Airworthiness Directive: 135
Date: September 25, 2007
Subject: CAB-TANG Failure
Compliance: Mandatory
Models Affected: All RANS aircraft with cable braced tails.
(S-4, S-5, S-6ES, S-6S, S-7, S-9, S-10, S-12, S-12XL, S-12S, S-14, S-17, S-18)

Inspection Location:

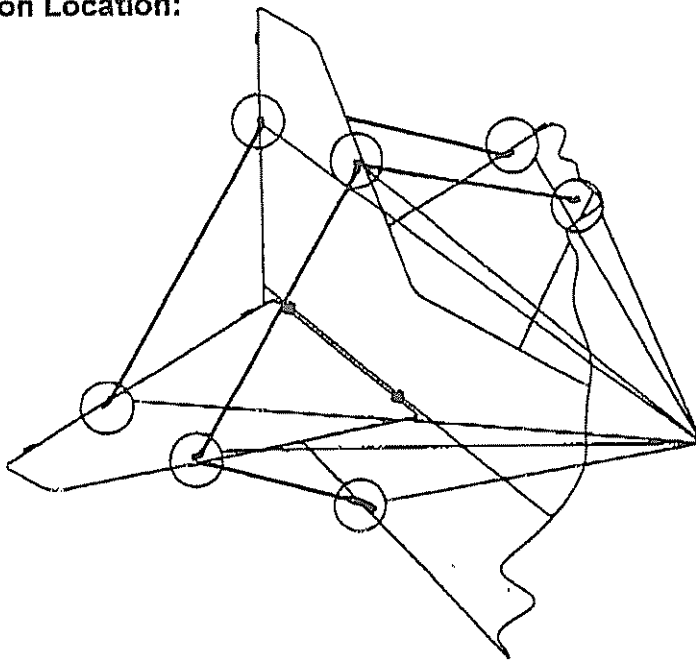
INSPECT ALL TAIL
CABLES AND TANGS

Inspect before next flight. If cracks or defects are found, remove the aircraft from service until it is possible to replace the cable assembly with latest revision.

Inspection Procedure:

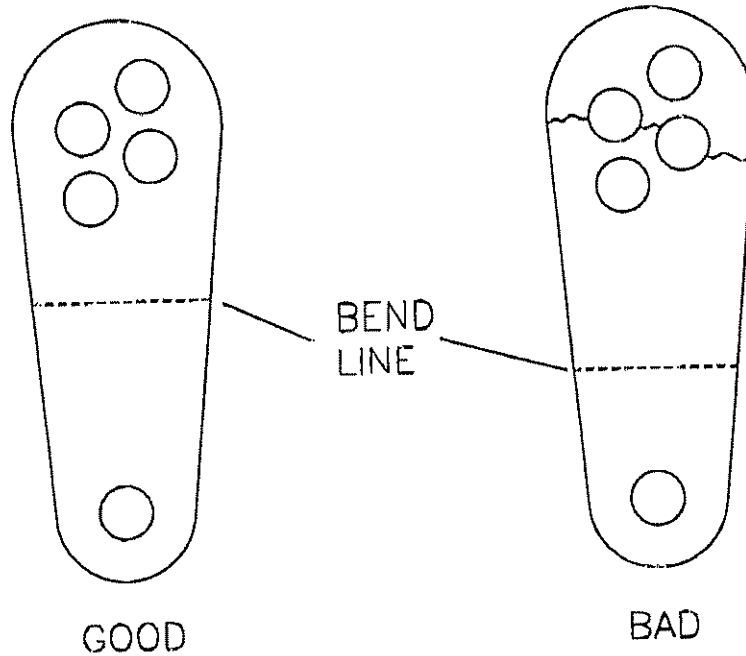
Remove bolts holding the CAB-TANG and inspect the tangs using a 10X magnifier.
